SUBJECT: Forwards updated responses to Seismic Review Team & Pump
 & Valve Operability Review Team audit open items. Util
 currently performing compliance & verification review of
 seismic qualification program.

Re: Nine Mile Point Unit 2
Docket No. 50-410

Enclosed for your information are certain updated responses to the Seismic Review Team and Pump and Valve Operability Review team Audit open items for Nine Mile Point Unit 2. Ten copies of the following information are provided:

FIGURE 1
SOLE PLATE PREROUTING DEVICES

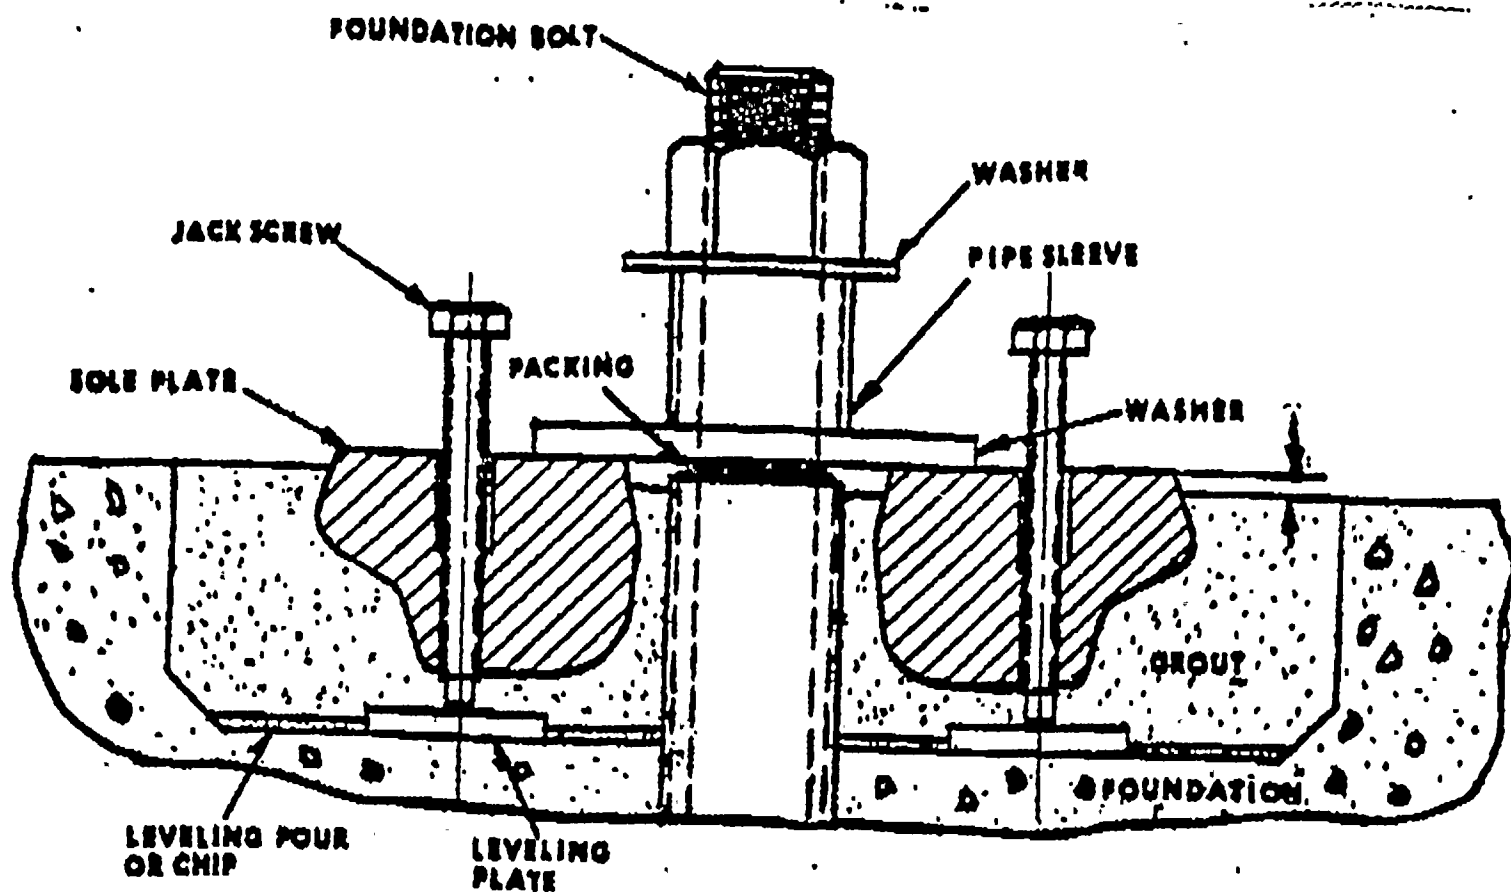
The use of loose shim plates in mounting the generator skid was not justified.

A review of the foundation drawing for installation of the generator skid (Cooper Bessemer Drawing No. KSV-97-16) found no loose shim plates specified for the generator mounting.

There appears to be a misunderstanding in terminology used. The above-referenced drawing refers to a sole plate which is placed on top of the grout, under the bottom washer of the foundation bolts (see attached sketch). The bolts were torqued to the specified value, and the sole plate was set and level in accordance with SWEC procedure SC-28-12, as verified and documented in the QC inspection report that was presented during the audit.

The installation drawing referenced above does not call for any shim plates to be used in the installation of the generator skid, and none were used as verified by field walkdown.
